Project	IEEE 802.16 Broadband Wireless Access Working Group < http://iee802.org/16 >	
Title	AI relative to Master/Slaves and further clarifications	
Date Submitted	2007-03-01	
Source(s)	Mariana Goldhamer Alvarion Tel Aviv, 21 HaBarzel Street Israel	Voice: +972 3 6456241 Fax: +972 3 645 6204 mailto:mariana.goldhamer@alvarion.com
Re:	[If this is a proposed revision, cite the original document.] [If this is a response to a Call for Contributions, cite the name and date of the Call for Contributions to which this document responds, as well as the relevant item number in the Call for Contributions. Contributions that are not responsive to this section of the template, and contributions which do not address the topic under which they are submitted, may be refused or consigned to the "General Contributions" area.]	
Abstract	[Description of document contents.]	
Purpose	[Description of what the author wants 802.16 to do with the information in the document.]

AI relative to Master/slaves and further corrections

(AIs from session #47 relative to comment 1007 and 1044)

Figure 31—Timing of the WLAN and WPAN subintervals

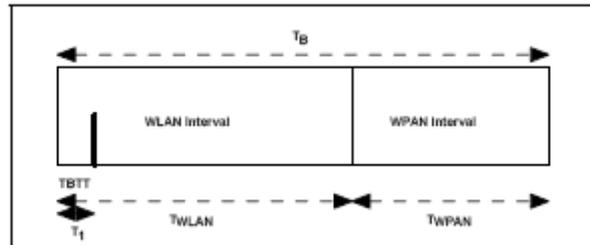
AI taken by Mariana to modify the figure and the text accordingly to move the shared frame to be the first in the coexistence frames.

This last AI was generated by the figure below, from IEEE P802.15.2 – Part 15.2: Coexistence of Wireless Personal Area Networks with Other Wireless Devices Operating in Unlicensed Frequency Bands.

The recommendation was to change the order, such that the Master for Bursty systems and Shared sub-frame will be placed at the beginning of the frame. However, may be one or two 802.11 Master systems in an area, and this will have as effect a variable position of the Shared sub-frames. In order to avoid this complication we prefer to use in continuation the existing figures, in which the place of the Shared sub-frame is fixed.

Fig h47' Example of a Coexistence Frame with only two systems

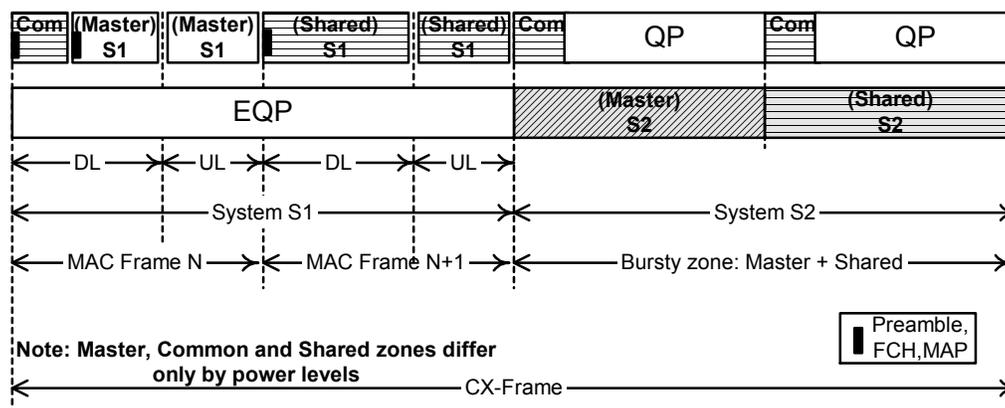
AI taken by Mariana, provide the figure addressing the sub-frames aspect for bursty system coexistence with WirelessMAN-CX

The figure h47' exemplifies the case of one 802.16h systems and one Bursty system, while the figure h47'' shows the situation of two 802.16h systems and one Bursty system. In the described case it is assumed that no system is implementing the CXP and that the 802.16h systems are not implementing "listen-before-send" which would allow them to work in parallel with 802.11 systems. The silence periods for both systems are noted, according their duration, as Quiet Period (QP) or Extended Quiet Period (EQP). Note that for bursty systems there is no DL/UL splitting. In the following two figures the reservation for bursty systems is shown with grey.
